STAFF RECOMMENDATION

1303 Eastland Avenue

Application: DADU conversion

Description of Project: Application is to convert an existing outbuilding to a DADU.

1303 EASTLAND AVE.
 PROPOSED
 GARAGE CONVERSION

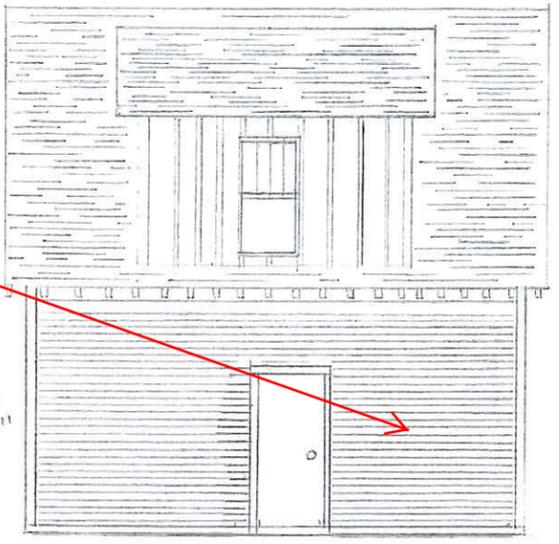
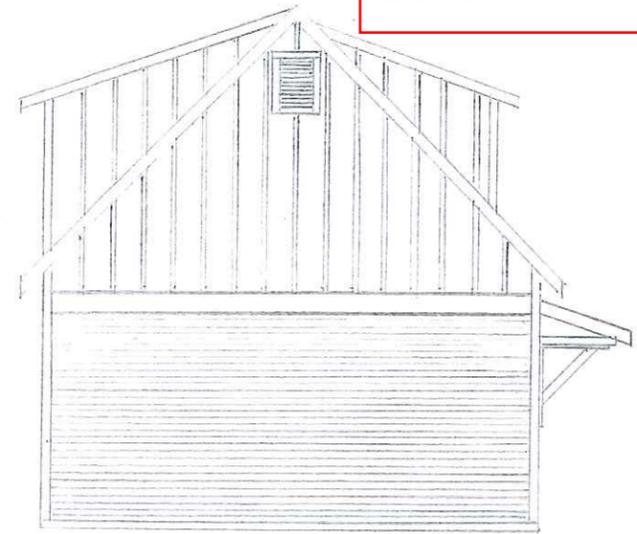
MHZC Note:
 cladding on rear
 facade may be lap
 siding or vertical
 board and batten.

REAR
 FRONT

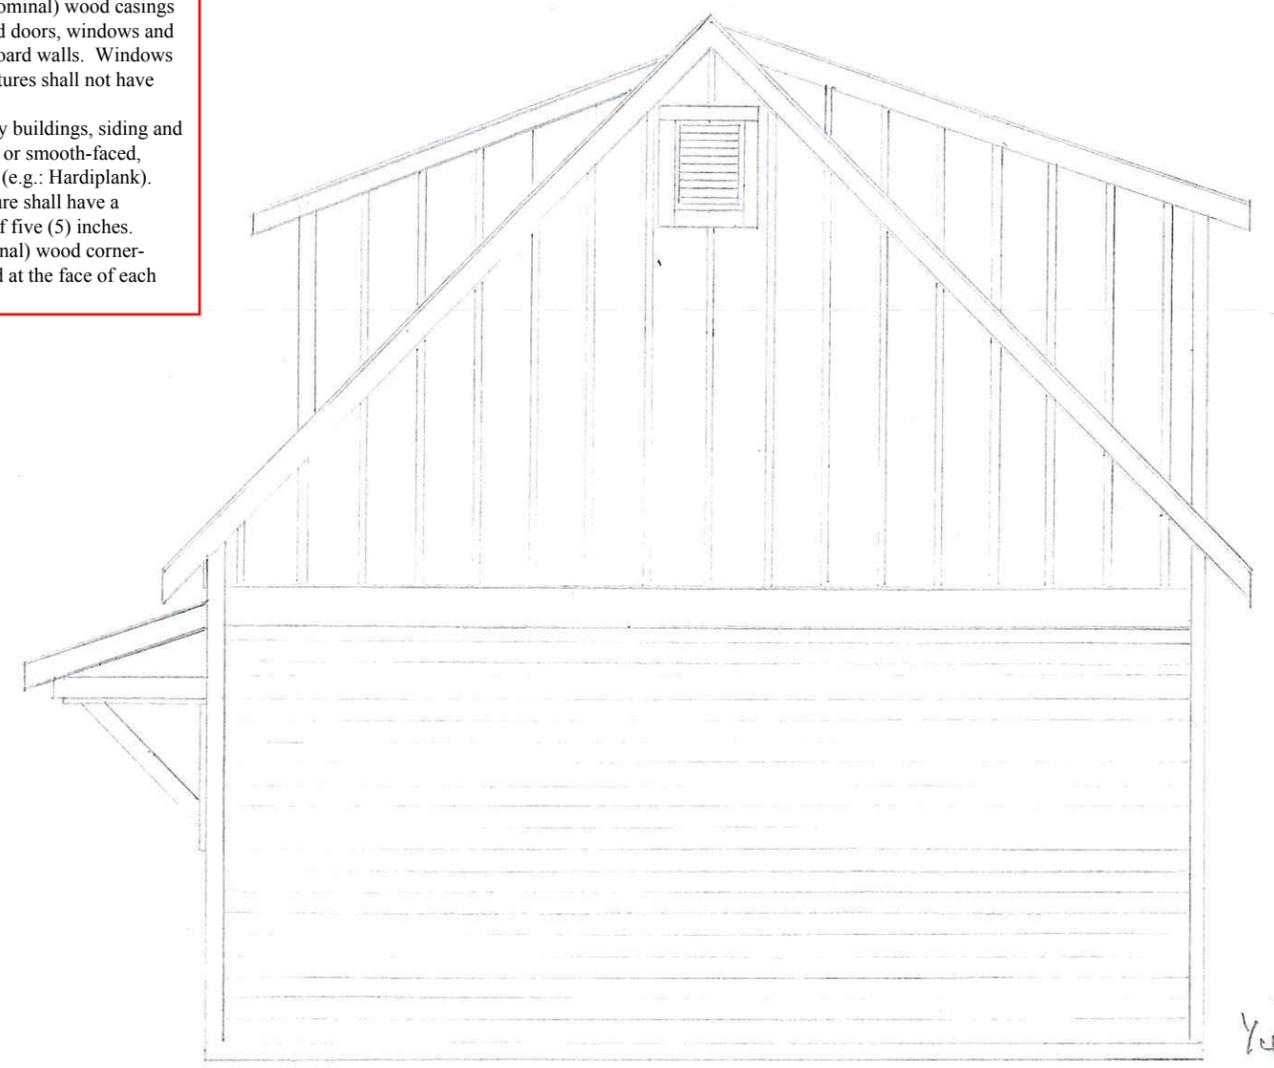
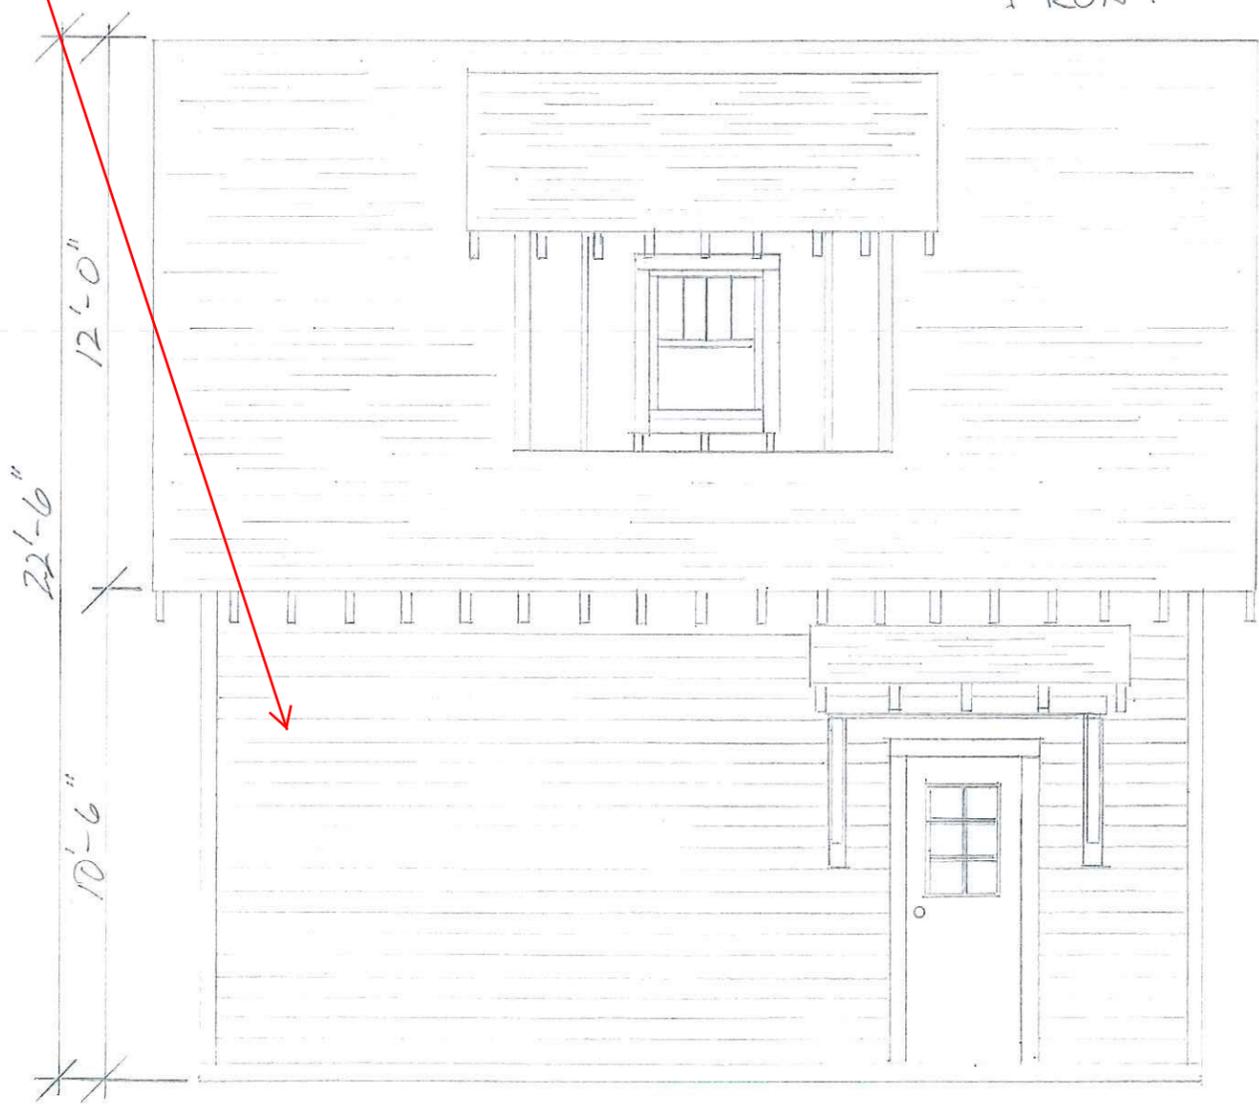
MHZC Note:
 applicant to retain
 existing siding on
 most facades.
